Steve Rainey Fish Passage Engineering
15313 SE Evergreen Hwy
Vancouver, WA 98683
Cell: 503-260-6990

RE: Memorandum – November 10, 2010 Bonneville (BON) Adult Fish Facility (AFF) Site Visit with Jeff Fryer CRITFC

Figure 1. Sketch of vee-trap at the FCP outlet channel.

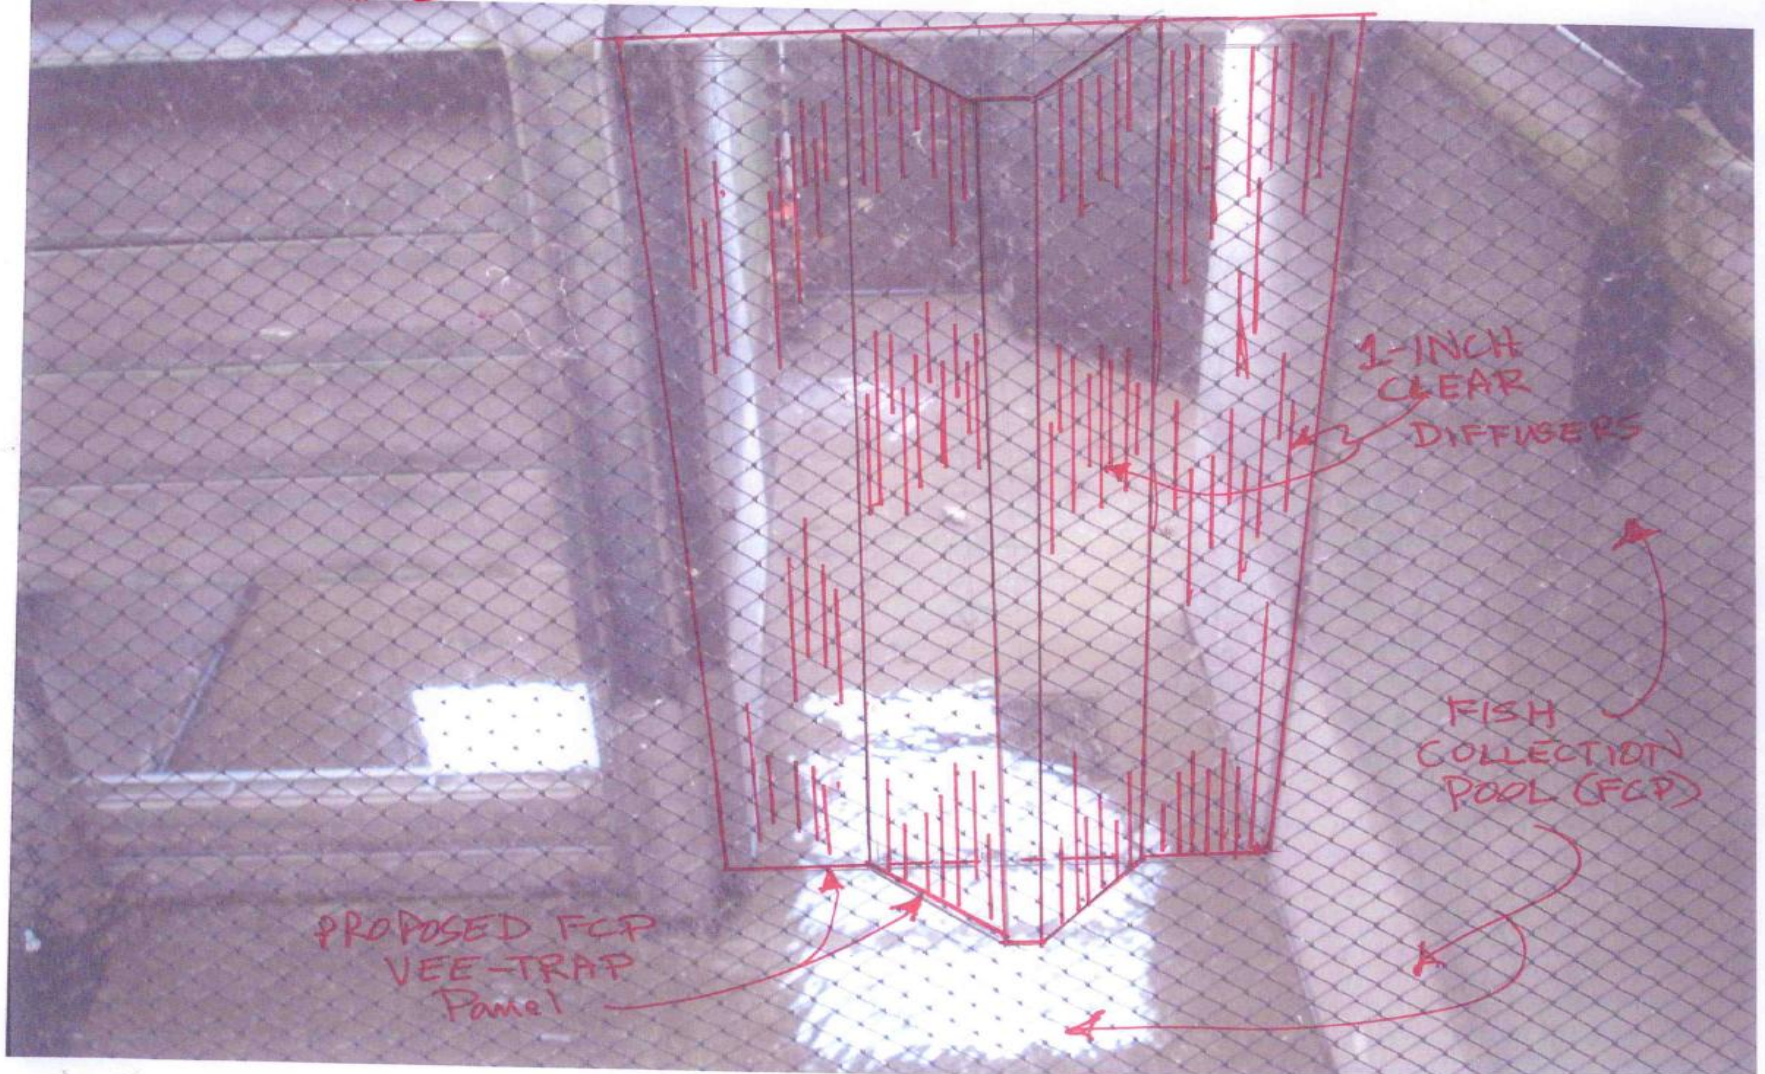
Description: The AFF Fish Collection Pool (FCP) is the large pool that is just upstream of the false weirs, and inside the AFF building. It is currently not an OLHP, because fish can enter and either pass over the false weirs, or egress the FCP and ladder, back to tailwater. Or, some may be descending a few pools, before re-ascending on the south side of the ladder and passing the portion of the angled diffuser pool with pickets raised. Therefore, addition of a vee-trap is recommended to convert the FCP to an OLHP. It can be lowered into the 8 ft wide channel at the FCP flow outlet, which is just inside the AFF building and leads from the FCP to the main ladder picket pool. 4-inch embedded guides on both sides would allow easy installation of a fabricated vee trap. While FCP floor diffuser flow (to attract fish into the sample loop) would be the basis for structural design of the vee-trap, it would need to be large enough to occlude the 8 ft wide x 16 ft deep channel. Design of the vee-trap would need to entail enough velocity to assure proper function, so that adult fish would have to back out instead of leaving head-first. I suspect this would require a minimum upstream approach velocity of 1 fps. (See Figure 1 sketch of vee-trap at the FCP outlet channel.) Note that the vee-trap panel may need to be designed to be lowered into the confined slot in the access deck, then hinged panels cocked into place to attain the vee configuration (a design detail). Functionally, fish blocked by a period of lowered picketed diffusers completely across the main ladder would be able to either enter the FCP through the vee-trap (making it an OLHP) or reject entry into the AFF through the vee-trap and (initially) descend the ladder.

At BON 2nd ladder, wary behavior of adult salmon and steelhead may be responsible for rejection of composite lowered pickets and the more confined side channel leading to the FCP. It is probable that many fish entered the FCP, spent a relatively short period looking for an acceptable route upstream, rejected passing over the false weir(s), and purposely dropped back down the ladder. One reason is that there was no trapping mechanism for fish entering the FCP. Even after installing the longitudinal diffusers, a large percentage of fish may be rejecting the sample loop route, and falling back one or more pools to re-ascend the ladder on the south side of the ladder. If a vee-trap is installed as recommended above, it is possible that some blocked fish will approach the vee-trap, before rejecting it and purposely falling back. However, it is expected that many will pass through the large vee-trap before deciding to move back down the ladder. They will be unable to egress the FCP, which the vee-trap has converted into an OLHP. Their only egress will be the false weir(s), which can be turned on and off to control the number of fish passing down the flume to the anesthetic tank.

As necessary, the vee-trap can be designed/adapted for PIT tag detection.

Figure 2. Proposed new AFF brail pool exit. (The exit could also be moved one panel downstream with modifications to the lifting mechanism to avoid the sockeye recovery tank return flume.)

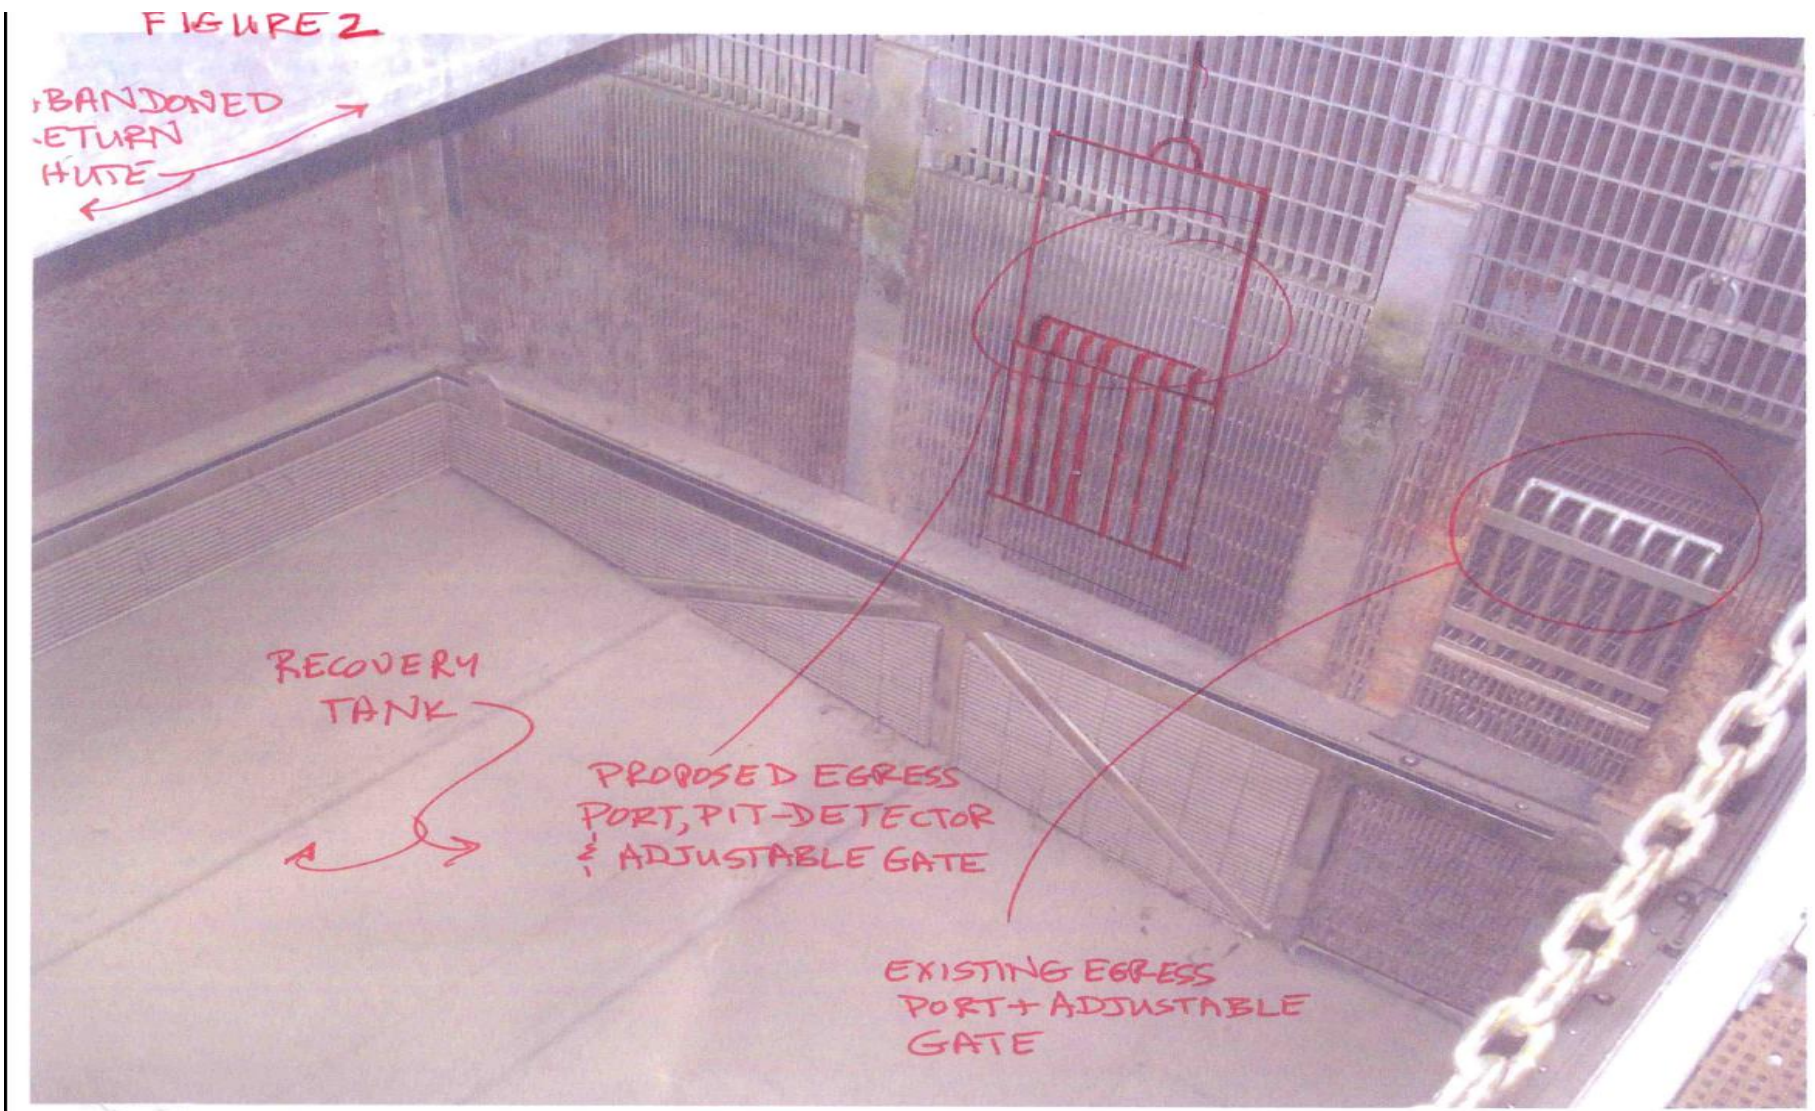
Existing situation: After fish pass through the enlarged anesthetic tank, they are routed to a brail pool, which serves as a record tank, located adjacent to a return channel to the half ice harbor fish ladder (which leads to the main ladder). The return channel passes enough flow that adult fish are attracted in an upstream direction to the return ladder; however, flow passes through a large “grizzly” dewatering grate just downstream of the recovery tank. Flow passes this on the way to a closed pipeline that drains flow from the AFF. The concern is that fish passing out of the recovery tank (potentially partially under the influence of anesthetic) can be swept back a few feet and impinged on the grizzly. The reason is that velocities accelerate as return channel flow passes through the grating. Meanwhile, CRITFC previously desired to install a PIT detector in the existing small return opening from the brail pool to the adjacent fish return channel. However, due to the presence of vertical structural steel wide-flange posts (which also serve as guides to maintain the ‘wall’ diffuser partition between the recovery tank and return channel) the PIT detectors would need excessive shields to limit detector metallic field. Shields would extend into the return channel, and (very incrementally) increase velocity just upstream of the grizzly, which was objectionable to FPOM.

As the AFF was dewatered during our November 10 site visit, we climbed down into the return channel, and observed that existing steel diffuser panels are starting to show their age. Extensive rust was observed below the operating water level. Panels are 74 inches (high) x 40 inches (wide) and are perimeter banded, with 1-inch deep bars space and ½-inch clearance between bars. Bar thickness was 1/8 – 3/16 inch. Recommended actions to achieve CRITFC functional needs are to replace one of the recovery tank/return channel wall panels further upstream from the existing recovery tank fish egress port with a similarly sized port, which can be fabricated with hard strong plastic (or other) and shielded for PIT detection without a projection into the return channel. Like the existing return port, it could be designed with an upward-closing diffuser panel. (See Figure 2)
